# WATER QUALITY M E M O R A N D U M

Utah Coal Regulatory Program

RE: 2010 4<sup>th</sup> Quarter Water Monitoring, Genwal Resources, Inc., Crandall Canyon Mine, Permit & Tracking #3690

### Crandall Creek Lower Flume (LOF-1): Total Iron Levels

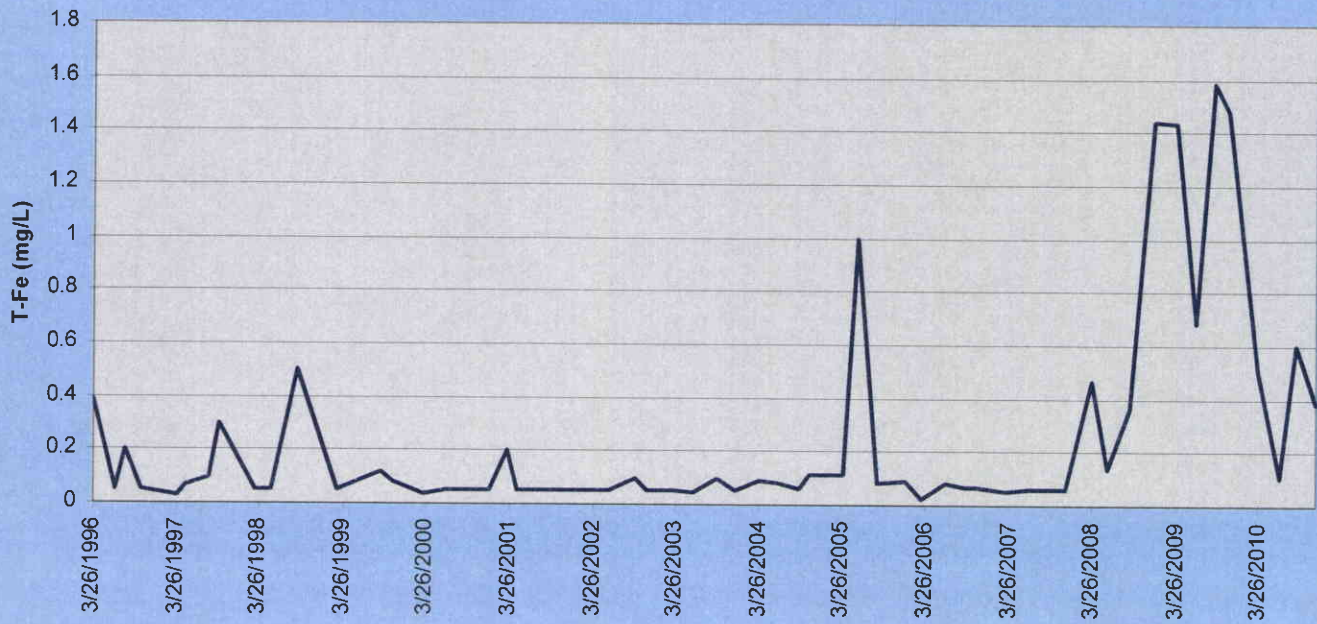
As the total iron (T-Fe) concentrations in the mine-water discharge began to increase, a concern was that a similar rise would be observed in stream monitoring site LOF-1 (lower Crandall Canyon flume). An upward trend of T-Fe began to surface the second quarter of 2008 in correspondence with the increase in iron concentrations of the mine-water discharge. A T-Fe concentration of 1.479 gpm was reported the fourth quarter of 2009. Once the mine-water treatment system became operational during the 1<sup>st</sup> quarter of 2010, the iron concentrations detected at LOF-1 have dropped significantly. The T-Fe concentration for LOF-1 this quarter was 0.38 ppm.

## Mine Water Discharge (Outfall 002)

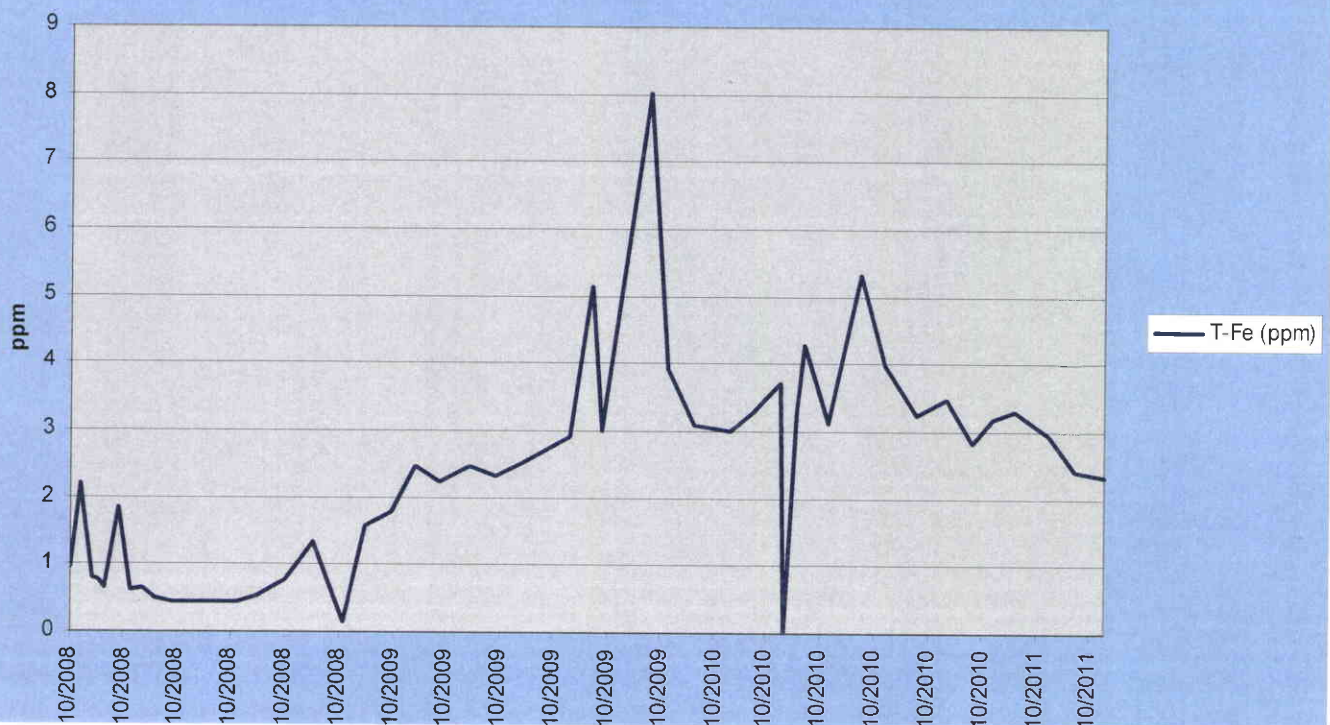
Based upon three sampling events, outfall 002 reported an average flow value of 528 gpm. The T-Fe concentrations of the water discharging from the mine-water treatment basin were well within the 1.0 ppm standard established by the UPDES permit (0.46 ppm, 0.43 ppm and 0.46 ppm for October, November and December respectively). The mine-water treatment system continues to be effective in reducing the T-Fe concentrations to within the UPDES discharge permit limit of 1.2 ppm.
